Access Compliance Report

Public Rights-of-Way

(Curb Ramps)

Intersection ID: 48166	Main Street: NORTHLAKE_MALL_DR	Cross Street: NORTHLAKE_CENTRE_PY	Location: SE
ADA ID: D7E5D2A75227	Ramp Type: Perp	Initial Pass/Fail: Fail	Overall Compliance: No
Severity Score: 37.5			
Codes/Mitigation Info/Possible Solution		Field Measurements/Component Compliance

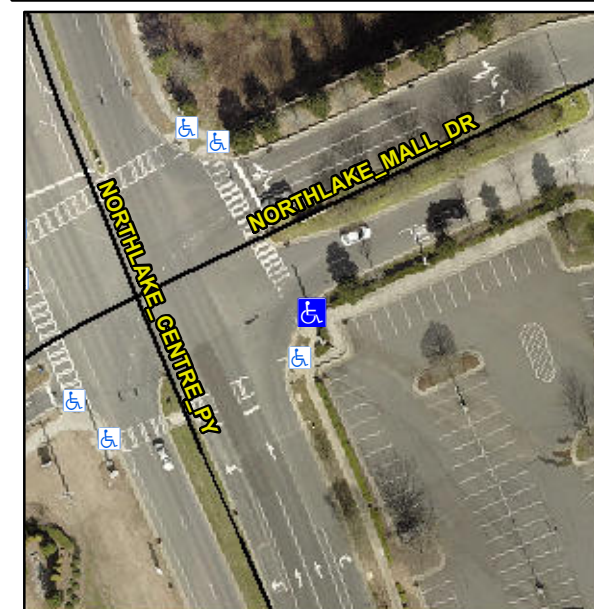
Not Found, R304.2.2, R304.5.3

Compliance	Description	Data	Compliance	Description	Data
N/A	Ramp Length (in)	54.0	No	Ramp Slope (%)	13.3
Yes	Ramp Width (in)	54.0	No	Ramp XSlope (%)	5.2
N/A	Flare Type LT	N/A	N/A	Flare Type RT	N/A
N/A	Flare Slope LT (%)	N/A	N/A	Flare Slope RT (%)	N/A
N/A	Flare Traversable LT?	N/A	N/A	Flare Traversable RT?	N/A
N/A	Landing Length (in)	N/A	N/A	DWS Provided?	N/A
N/A	Landing Width (in)	N/A	N/A	DWS Contrast?	N/A
N/A	Landing Slope (%)	N/A	N/A	DWS Length (in)	N/A
N/A	Landing X Slope (%)	N/A	N/A	DWS Full Width?	N/A
N/A	Landing Curb? (Y/N)	N/A	N/A	DWS Offset (in)	N/A
N/A	Shared Landing?	N/A			
N/A	Gutter Ponding?	N/A	N/A	Gutter Slope (%)	N/A
N/A	Gutter Lip Ht (in)	N/A	N/A	Gutter X Slope (%)	N/A
N/A	Painted X Walk1?	Yes	N/A	Painted X Walk2?	N/A
	X Walk 1 Direction	To N		X Walk 2 Direction	N/A
N/A	X Walk 1 Width (in)	103.0	N/A	X Walk 2 Width (in)	N/A
	X Walk 1 Slope (%)	5.8		X Walk 2 Slope (%)	N/A
	X Walk 1 X Slope (%)	1.5		X Walk 2 X Slope (%)	N/A

Possible Solutions:

Remove & Replace Entire Ramp.
